# Access Compliance Report

## Public Rights-of-Way

Intersection ID: 22200	Main Street: S_TRYON_ST	Cross Street: JOHN_PRICE_RD	Location:	N
ADA ID: 74F45AF27525	Ramp Type: MedianPerp	Initial Pass/Fail: Fail	Overall Compliance: No	Severity Score: 12.5
Codes/Mitigation Info/Possible Solution		Field Measurements/Component Compliance

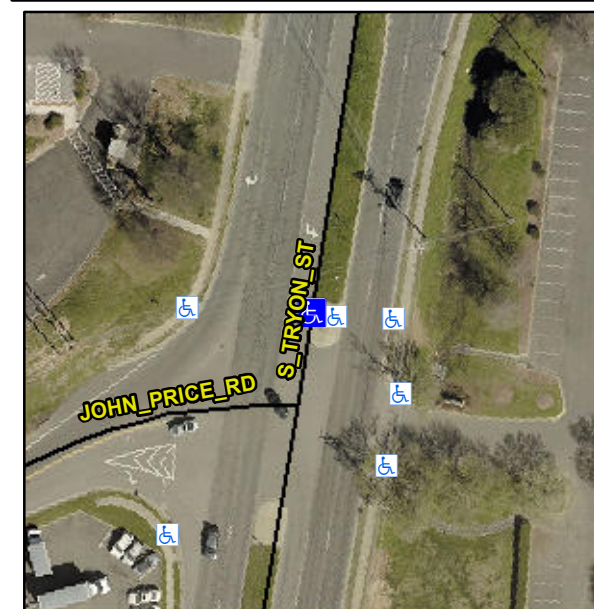
**Remove & Replace Entire Ramp.**

**Not Found, R304.2.2**

Compliance	Description	Data	Compliance	Description	Data
N/A	Ramp Length (in)	75.0	No	Ramp Slope (%)	9.8
Yes	Ramp Width (in)	48.0	Yes	Ramp XSlope (%)	1.6
N/A	Flare Type LT	N/A	N/A	Flare Type RT	N/A
N/A	Flare Slope LT (%)	N/A	N/A	Flare Slope RT (%)	N/A
N/A	Flare Traversable LT?	N/A	N/A	Flare Traversable RT?	N/A
N/A	Landing Length (in)	N/A	N/A	DWS Provided?	N/A
N/A	Landing Width (in)	N/A	N/A	DWS Contrast?	N/A
N/A	Landing Slope (%)	N/A	N/A	DWS Length (in)	N/A
N/A	Landing X Slope (%)	N/A	N/A	DWS Full Width?	N/A
N/A	Landing Curb? (Y/N)	N/A	N/A	DWS Offset (in)	N/A
N/A	Shared Landing?	N/A			
N/A	Gutter Ponding?	N/A	N/A	Gutter Slope (%)	N/A
N/A	Gutter Lip Ht (in)	N/A	N/A	Gutter X Slope (%)	N/A
N/A	Painted X Walk1?	No	N/A	Painted X Walk2?	N/A
	X Walk 1 Direction	To W		X Walk 2 Direction	N/A
N/A	X Walk 1 Width (in)	N/A	N/A	X Walk 2 Width (in)	N/A
	X Walk 1 Slope (%)	2.5		X Walk 2 Slope (%)	N/A
	X Walk 1 X Slope (%)	0.8		X Walk 2 X Slope (%)	N/A
